## XC27x4X Derivatives

16/32-Bit Single-Chip Microcontroller  
with 32-Bit Performance  
XC2000 Family / Value Line

Errata Sheet

V1.4 2009-10

**Figure 1 Loss of Arbitration**

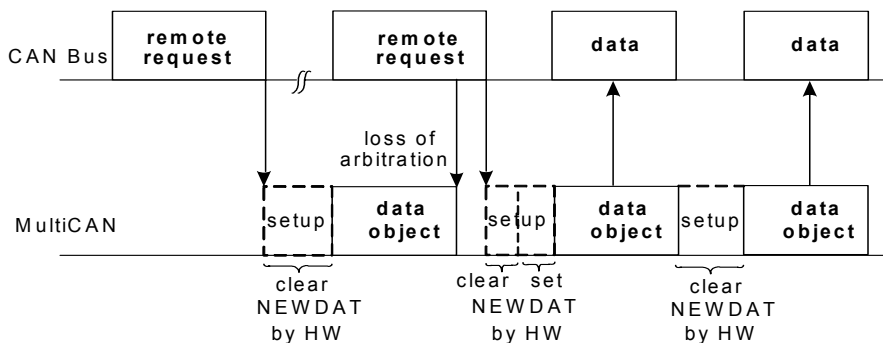
### **MultiCAN\_TC.H004 Double remote request**

Assume the following scenario: A first remote frame (dedicated to a message object) has been received. It performs a transmit setup (TXRQ is set) with clearing NEWDAT. MultiCAN starts to send the receiver message object (data frame), but loses arbitration against a second remote request received by the same message object as the first one (NEWDAT will be set).

When the appropriate message object (data frame) triggered by the first remote frame wins the arbitration, it will be sent out and NEWDAT is not reset. This leads to an additional data frame, that will be sent by this message object (clearing NEWDAT).

There will, however, not be more data frames than there are corresponding remote requests.

**Figure 2 External Clock Drive XTAL1**

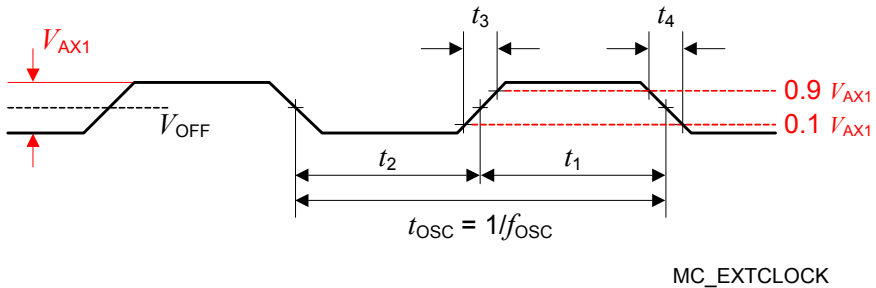
### XTAL\_X.D001 Input Voltage Amplitude $V_{AX1}$ on XTAL1

In the Data Sheet section "External Clock Input Parameters" the following table and figure should be updated (major changes are marked **red**).

- 1) The amplitude voltage  $V_{AX1}$  refers to the offset voltage  $V_{OFF}$ . This offset voltage must be stable during the operation and the resulting voltage peaks must remain within the limits defined by  $V_{IX1}$ .
